45 Cholmeley Crescent, London N6 5EX - Application for Certificate of Lawfulness (ref. HGY/2023/338)

Further to my recent objection to the current application for a Certificate of Lawfulness for the proposed installation of an outdoor pool in the rear garden of number 45 Cholmeley Crescent, London N6 5EX (reference HGY/2023/3383), I am writing to provide further comment and clarification regarding my concerns.

Figure 2: Image showing level changes across the application site and the location of mature trees

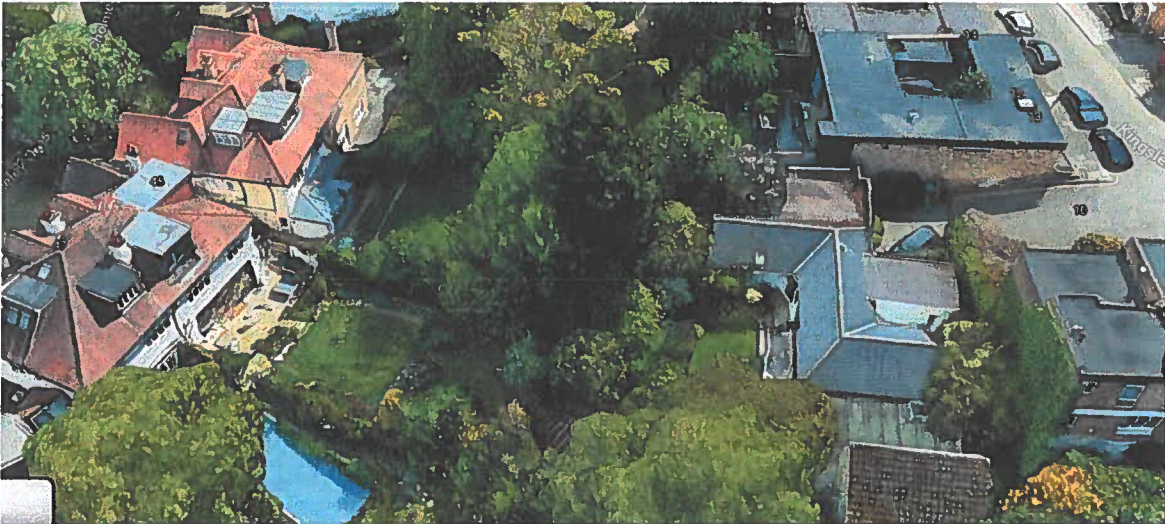
As shown in the image above, there are a number of mature trees within the site and along the boundary of the site. There is an existing TPO for 34 trees along the rear boundaries of the properties on Cholmeley Crescent /Kingsley Place (TPO 4-12 Kingsley Place, reference TPO/2014/0555) and these are not shown on any of the submitted drawings. Of particular note are four mature trees along the boundary with properties on Kingsley Place, comprising an ash tree of 14m, with a stem radius of 600mm; a sycamore tree of 19m and a stem radius of 555mm; and two Leyland Cypress of 12 metres height and 550mm and 250mm stem radius.

Figures 5 and 6: Siting and appearance of the proposed swimming pool

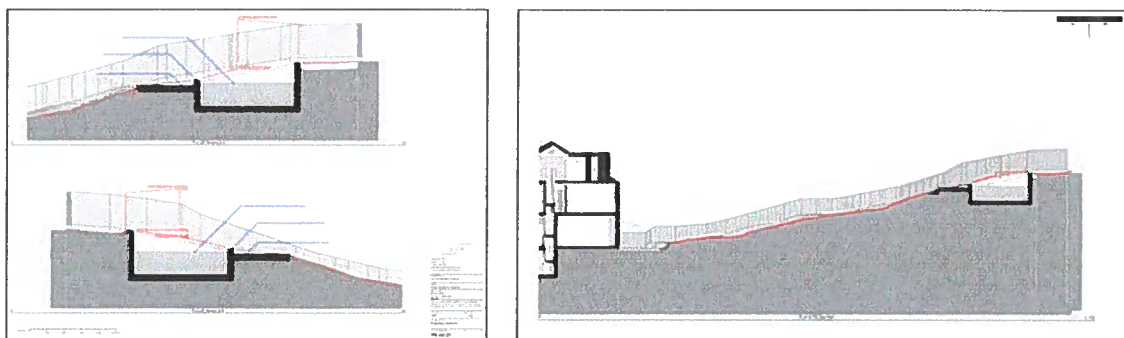
Drawing number PR-A1.01 (above) shows the siting and dimensions of the proposed swimming pool. The pool will be located at the highest point of the garden, in close proximity to the boundaries with 43 and 47 Cholmeley Crescent, to the south and north; and 12 Kingsley Place to the west. A concrete pool edge will be located on all sides of the pool right up to the boundary line with the adjoining properties to the north and south, and a polished concrete patio will be created to the east of the pool, across the whole width of the garden at this point.

The proposed swimming pool is located in the western part of the site, close to the boundary with 12 Kingsley Place. The proposals do not show the location of any pool house/ plant, which could be noisy. As shown on drawing number PR-A2.01, it is proposed to increase the height of the timber fencing separating the garden from adjoining properties to two metres.

I have serious concerns that the proximity of the proposal to the site boundary and to the existing mature trees along the boundary will impact on the existing protected TPO trees and their RPA and that the proposed works could not be carried out without damage to these protected trees. Moreover, many of these trees are outside of the application boundary and are not owned by the applicant. I would therefore request that an Arboricultural Assessment should be undertaken to assess any potential impact of the proposed works on the existing trees before the scheme is

considered. The application also fails to show details of how the structure would be constructed and how any existing trees would be protected.
